Application under the Agricultural Operation Practices Act for a confined feeding operation, manure collection area, and/or manure storage facility(ies)

<b>NRCB USE ONLY</b>	Application number	Legal land description
<input checked="" type="checkbox"/> Approval <input type="checkbox"/> Registration <input type="checkbox"/> Authorization <input type="checkbox"/> Amendment	<u>LA25002</u>	<u>NW 22-10-22 W4M</u>

**Re:                   Geotechnical Review and Evaluation  
                      NRCB Permitting of Proposed Catch Basin & Pen Expansion  
                      NW-22-010-22-W4M, near Shaughnessy, Alberta**

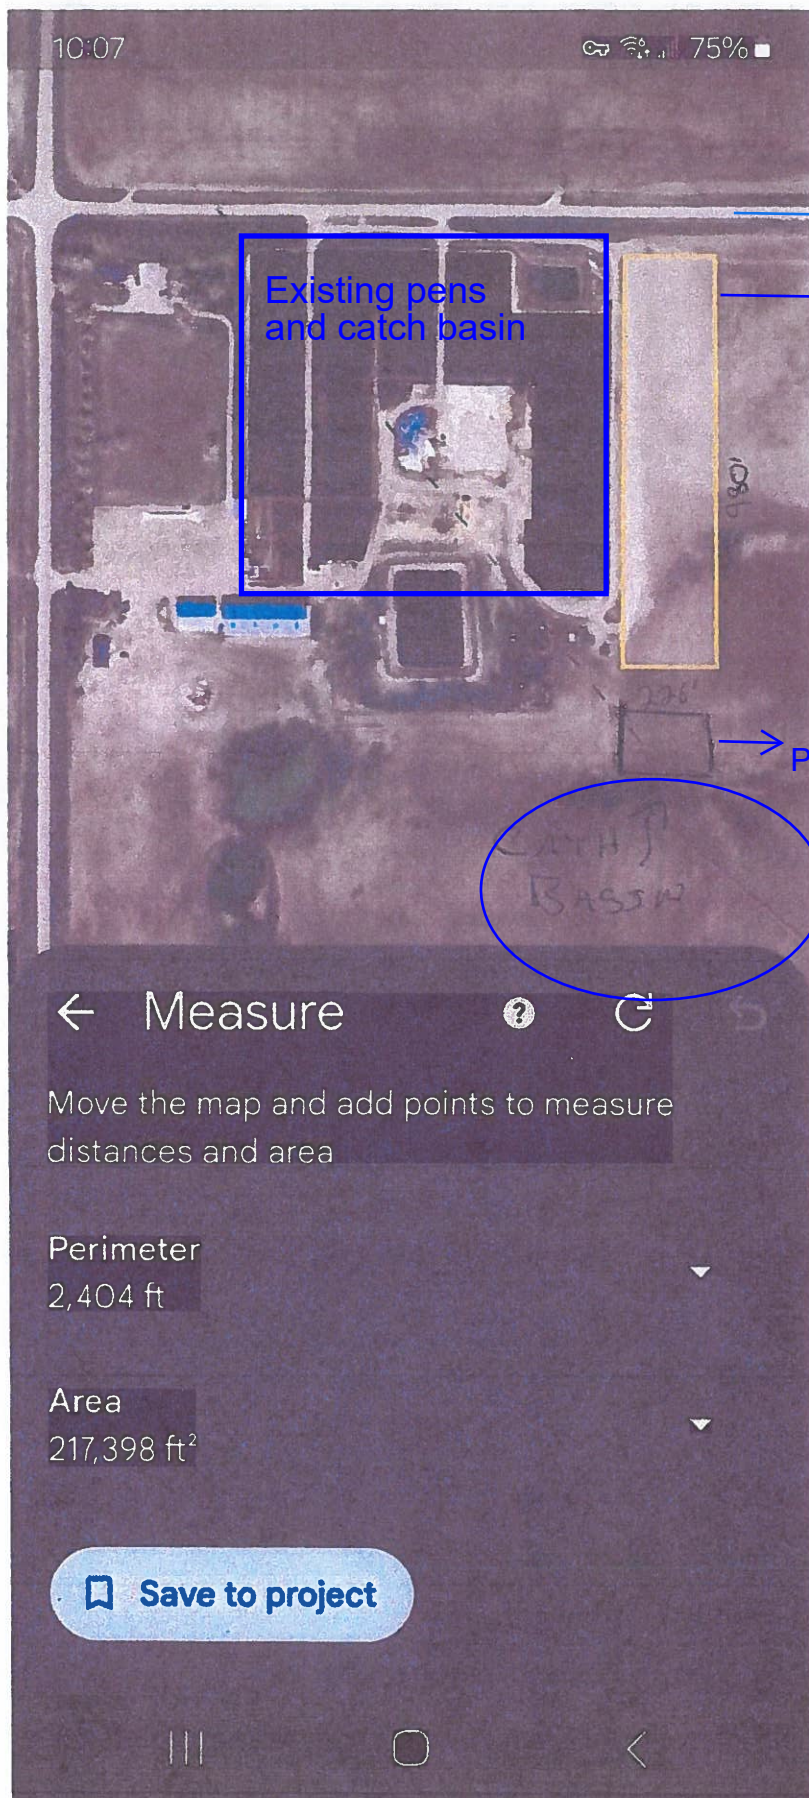
Applicant stated that they would apply for more water from the LNID.

→ The pens are proposed to be built east of, and parallel to, the existing feedlot pens. This area will be comprised of six pens (total dimensions of 299 m x 69 m). Additionally, this would put the proposed feedlot pens 33.1 m from the centre of Township Road 10-4. See Decision Summary LA25002 for a discussion of the county road setback and an explanation of the permit conditions.

→ Proposed catch basin (25 m x 55 m x 4 m deep)

→ There is an LNID pipeline approximately in the circled area, in close proximity to the proposed construction. It is the operators responsibility to contact the LNID and adhere to the 15 m setback required.

# Catch Basin Storage Volume Calculator

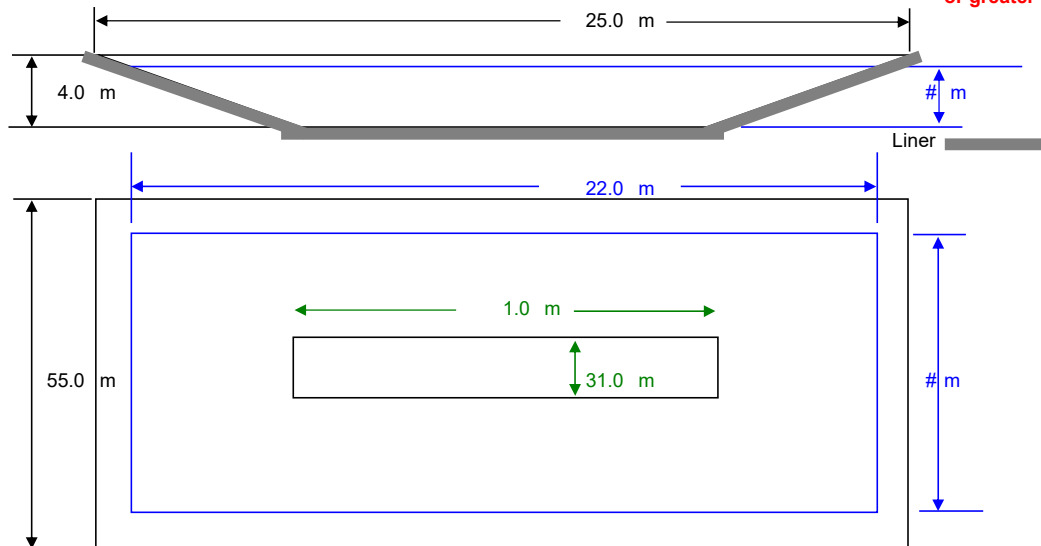
The proposed catch basin has sufficient volume if the pens are lined with roller compacted concrete (RCC).

- Figure 1 Borehole Locations
- In Situ Permeability Test Calculations
- Down to Earth Soil Texture Results
- Soil Profile and Parent Material Description, Chilako Drilling Services

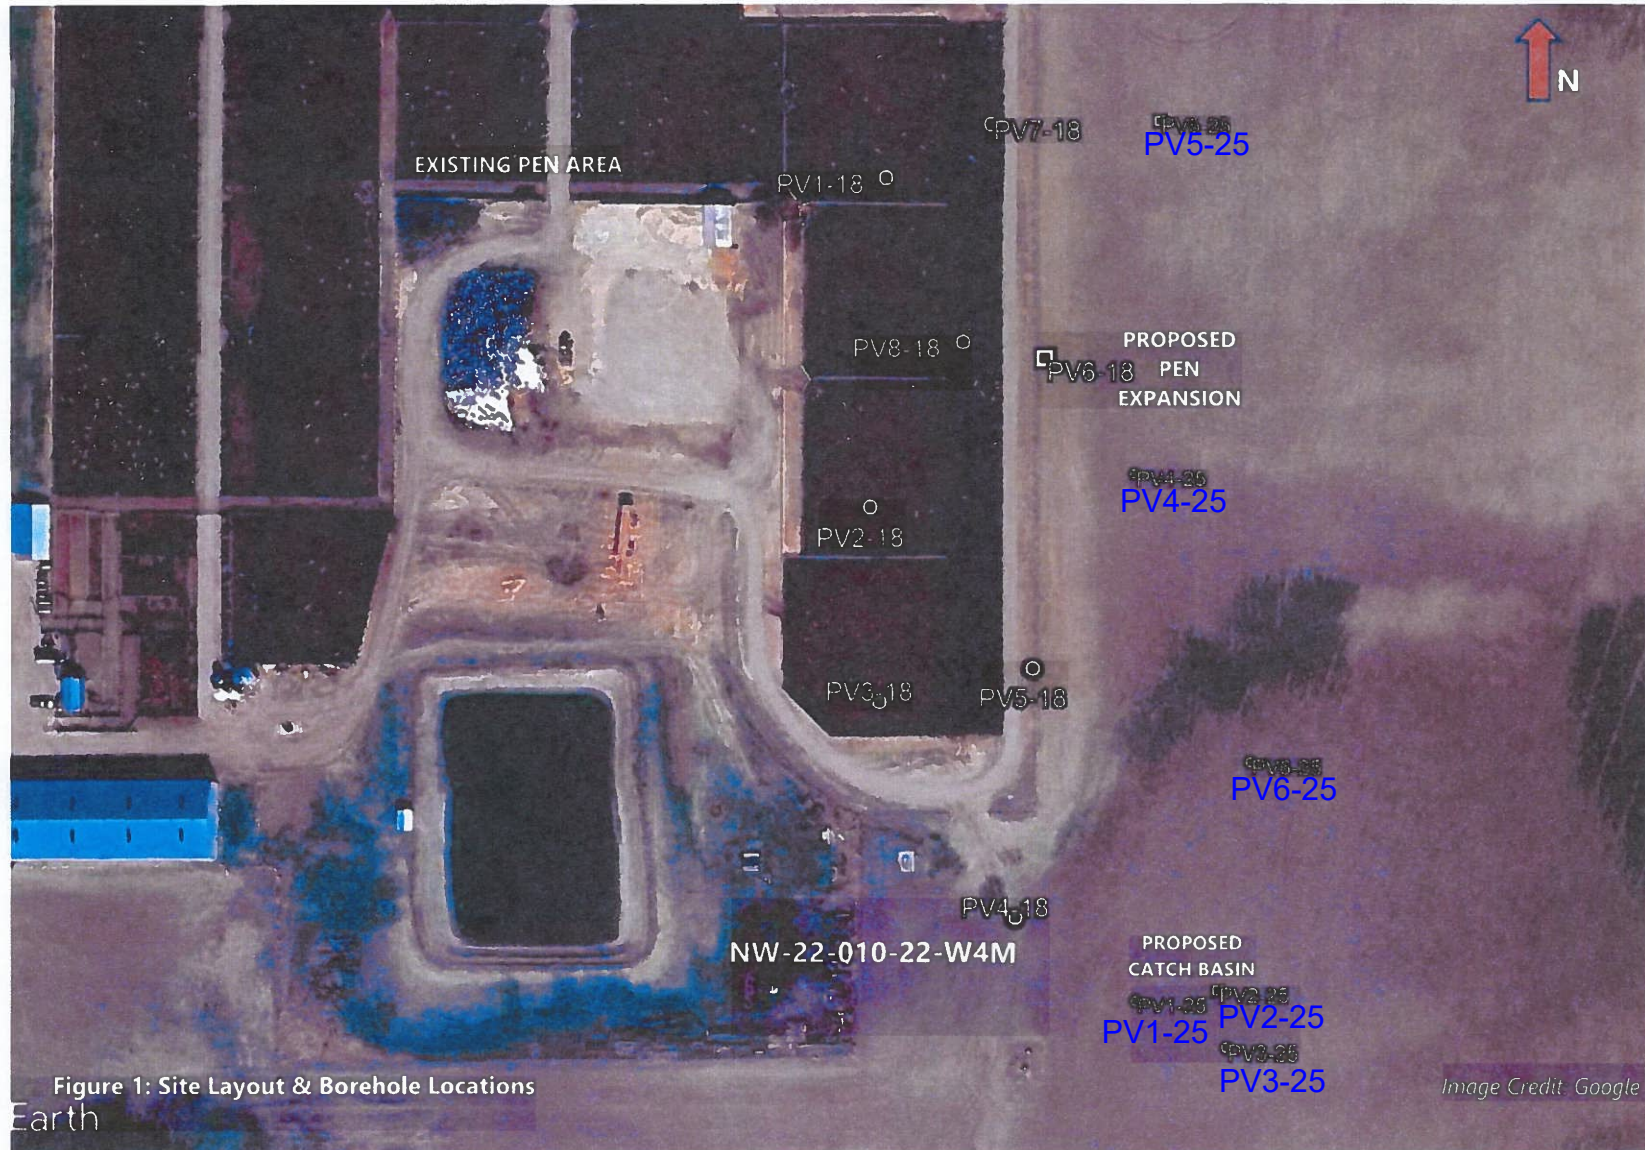
Site map also includes boreholes drilled in 2018 (those end in "-18"). Boreholes for LA25002 expansion end in "-25".
